APPLICATION FOR PERMISSION
UNDER SECTION 16 OF
THE TOWN PLANNING ORDINANCE
(CAP. 131)

For Official Use Only 請勿填寫此欄	Application No. 申請編號	A/4C SK/371
	Date Received 收到日期	22 APR 2024

(S.16 Planning Application No. A/YL-SK/371)

Figure 1 Part of the natural stream (circled in blue) would be within northern part of the site (marked in red)

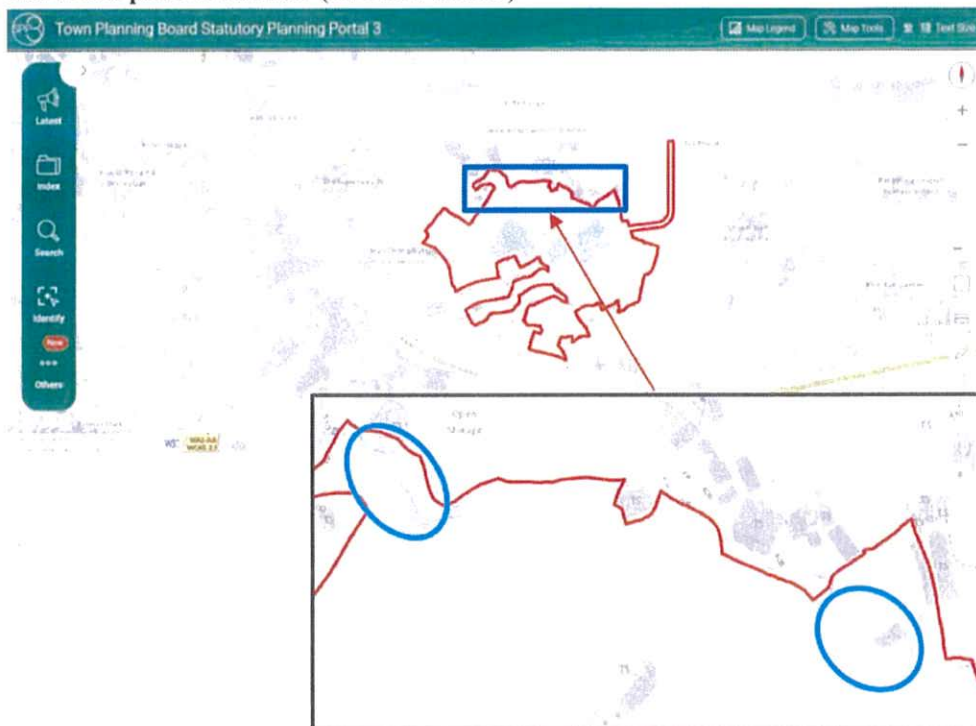
- Disturbance on natural stream: Part of the natural stream would be within northern part of the site (Figure 1). As stated by AFCD in “Response to Comment Table”, “*stream and watercourse should be preserved as far as possible from nature conservation perspective*”. However, we cannot see any attempts in achieving this purpose. Regarding the stream sections falling outside the site boundary, no buffer zones are provided. No details are available to demonstrate that no deterioration in water quality would be resulted during both construction and operation phase.

Figure 1 Part of the natural stream (circled in blue) would be within northern part of the site (marked in red)

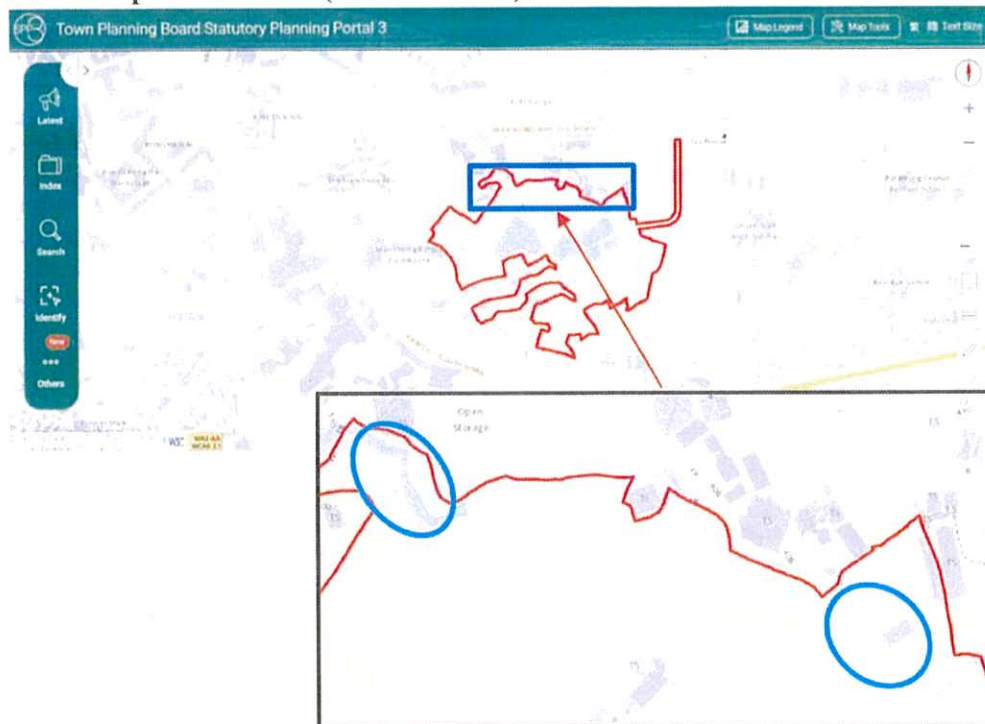
- Disturbance on natural stream: Part of the natural stream would be within northern part of the site (Figure 1). As stated by AFCD in "Response to Comment Table", "*stream and watercourse should be preserved as far as possible from nature conservation perspective*". However, we cannot see any attempts in achieving this purpose. Regarding the stream sections falling outside the site boundary, no buffer zones are provided. No details are available to demonstrate that no deterioration in water quality would be resulted during both construction and operation phase.

Figure 2-3 According to aerial photos (Source: Google Earth Pro), this site has been subject to land formation and vegetation clearance, and the extent kept expanding since February 2024. It is suspected that this is a case of “destroy first, build later”

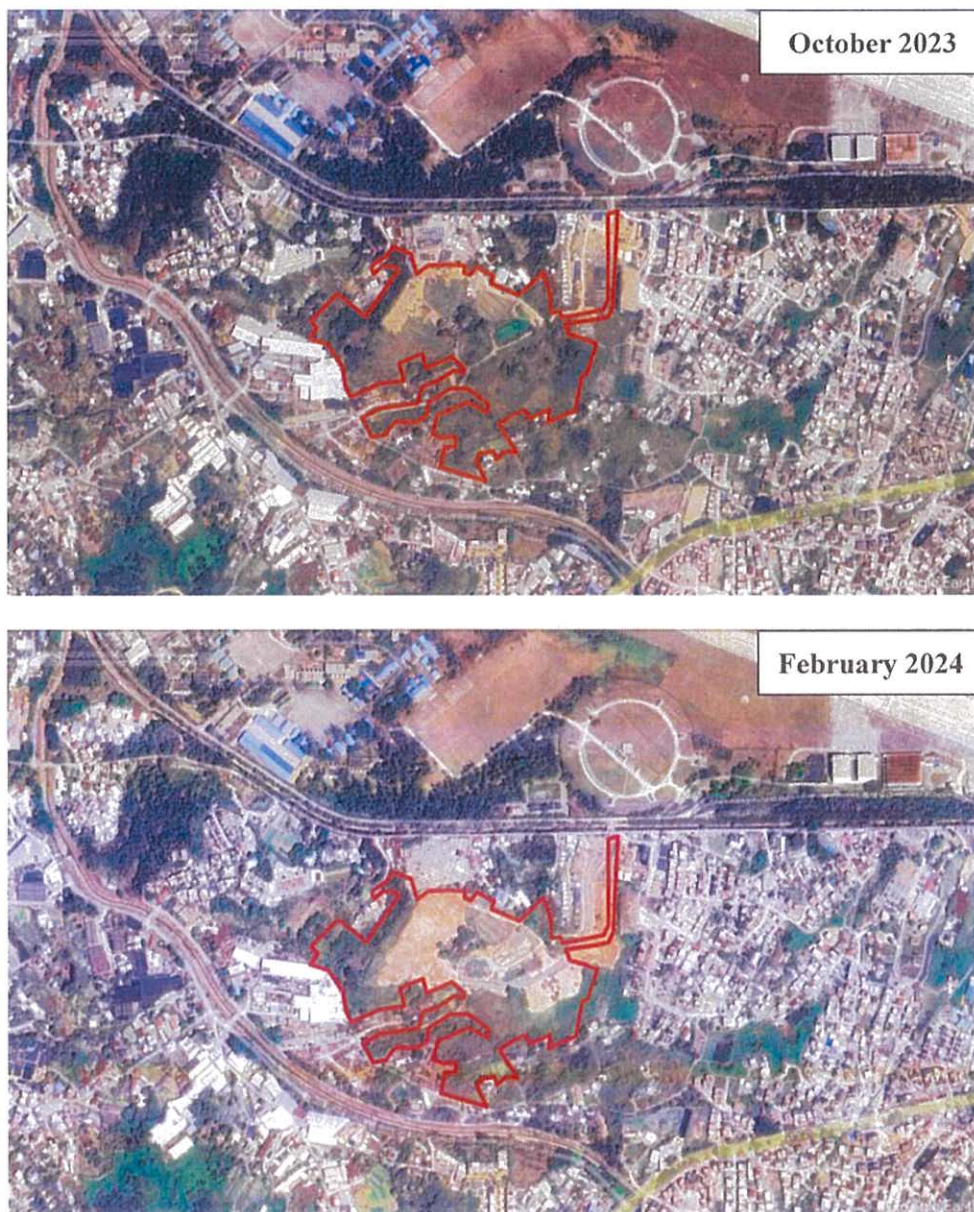
This site has been subject to land formation and vegetation clearance, and the extent kept expanding since February 2024 (Figure 2-3). It is suspected that this is a case of "destroy first, build later". Planning Department and members of Town Planning Board (TPB) should alert that TPB has announced approaches to deter "destroy first, build later" activities in 2011. It stated that "*the Board is determined to conserve the rural and natural environment and will not tolerate any deliberate action to destroy the rural and natural environment in the hope that the Board would give sympathetic consideration to subsequent development on the site concerned*"¹. Therefore, this application should not be given any sympathetic
